Subject: Channing Wall on Highgate High Street 2022/0044/P

## 2022/0044/P Channing Wall on Highgate High Street

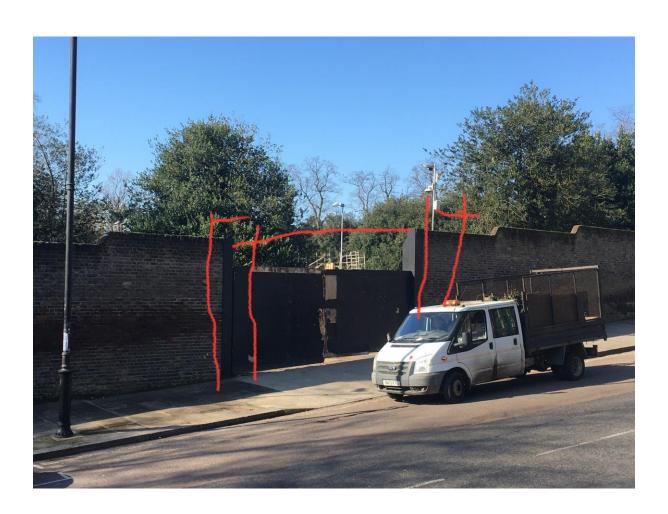
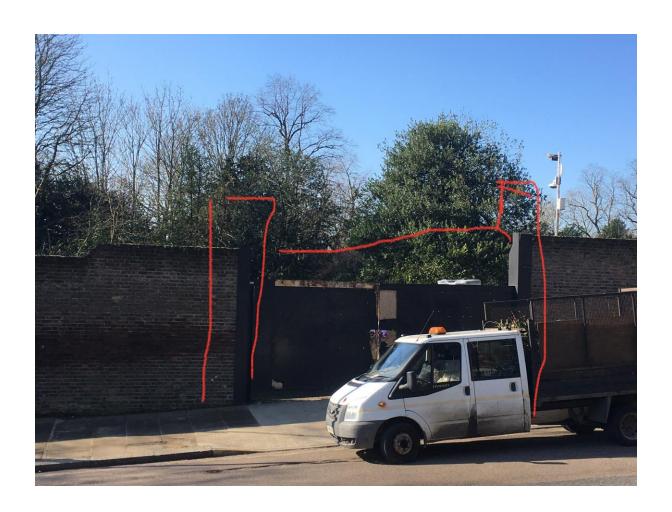
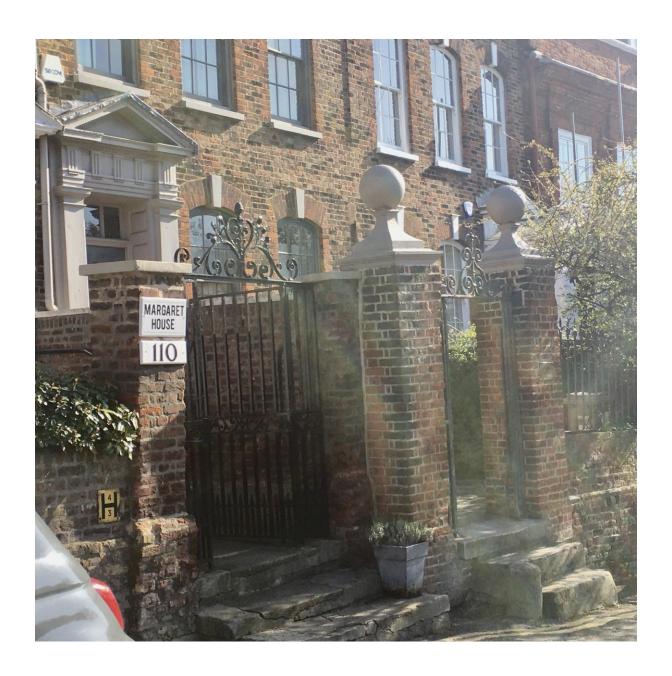
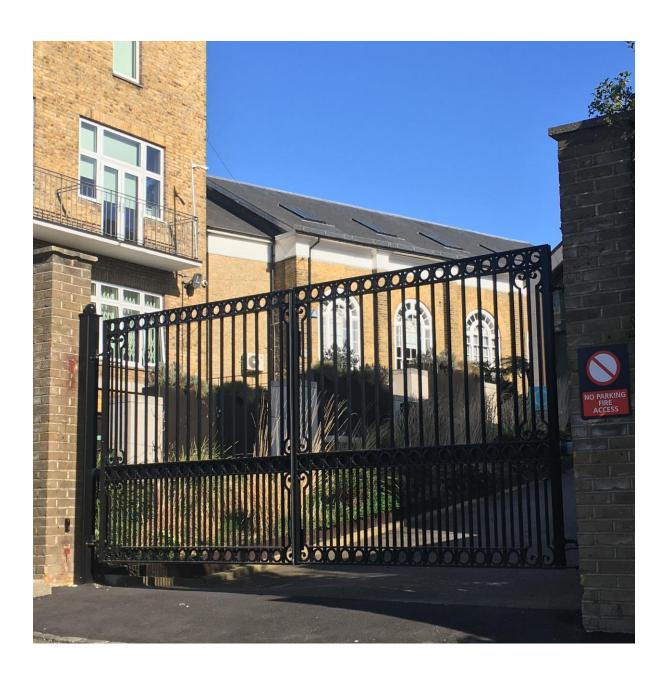
6. The other gates and entrances in the area, including Channing's own gate to the senior school on the Bank opposite, are open metalwork. See photos.

10. Many trees have been felled on the site. A blank gate built to the full height of the wall would cut off much of what little greenery is left and present an unrelieved built presence to what was once a verdant approach to Highgate Village. See photos

Highgate Hill c 1820-30

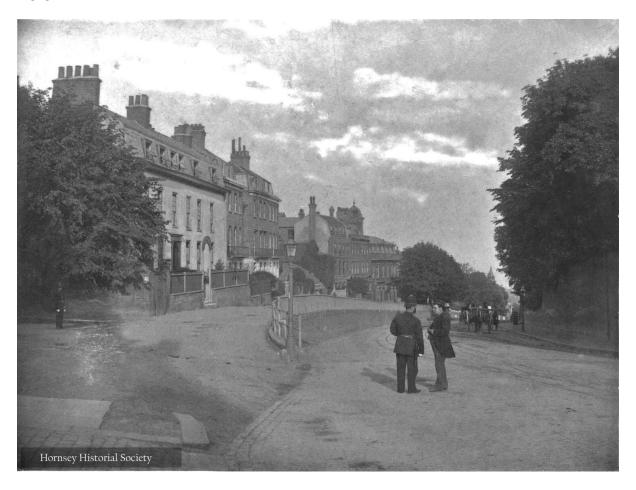
- 5. The wall is part of an iconic view of Highgate Hill, see attachment. The only large gate in that view is the entrance to Lauderdale House.
- 4. The only other entrance through this part of the wall is through a little side door. This gate totally overwhelms the domestic scale of the side door.
